UK Agriculture Research Facility 1 – Early Subcontractor Involvement Greenhouse

Project #2617.0-2-24

ADDENDUM # 2

4/2/2024

**A110.1**

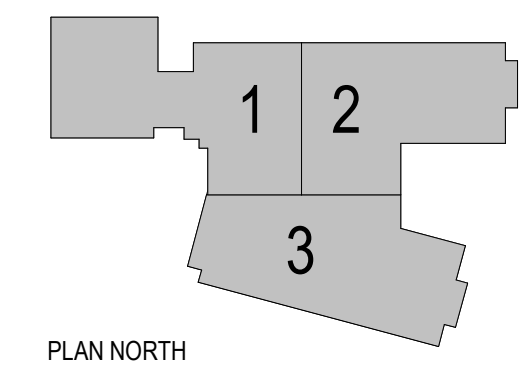
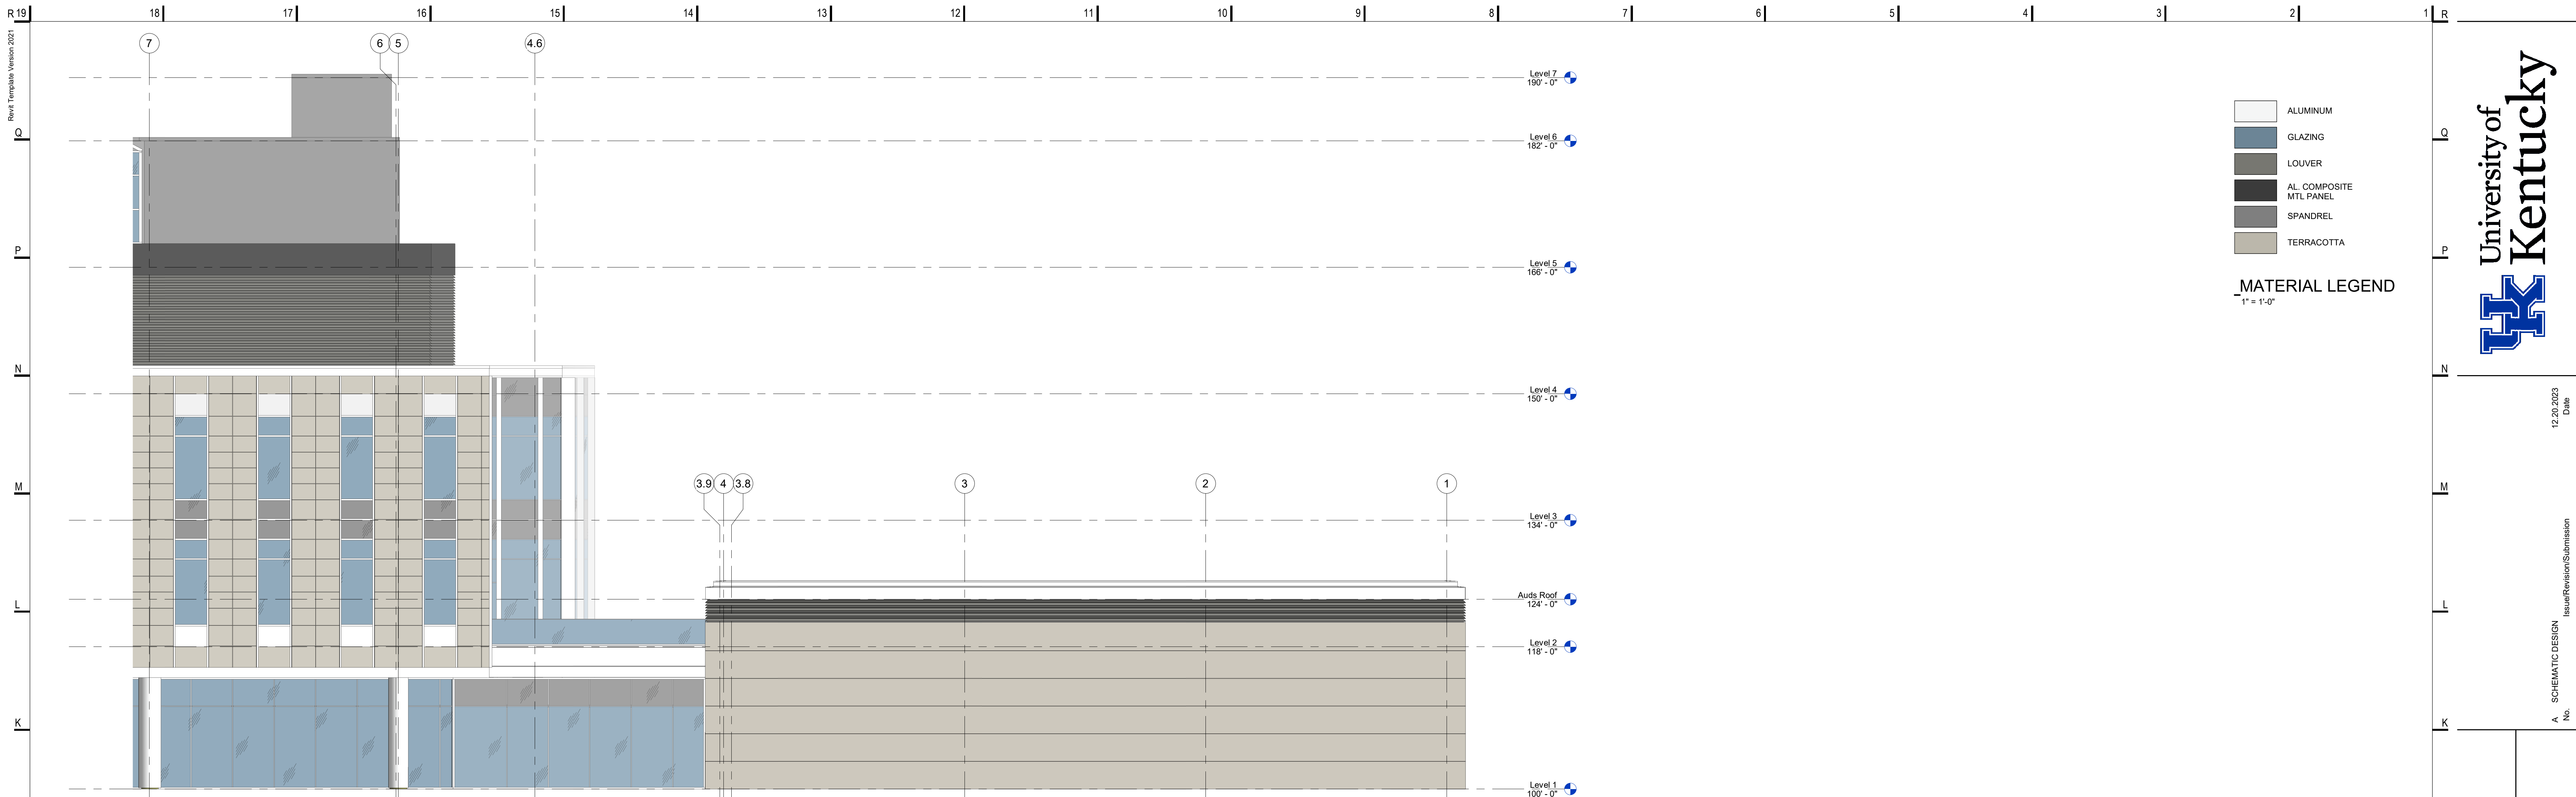
| #  | Question   | Responder           | Response   |
|----|--|---------------------|--|
| 8  | File uk-2617.0-2-24.pdf has 3 drawings for the greenhouses, would there be more drawings available showing grid dimensions and/or post location/dimensions etc.?   | Turner Construction | Included. See attached "UK Ag Research 1 - Overall Building Dims_20240219"   |
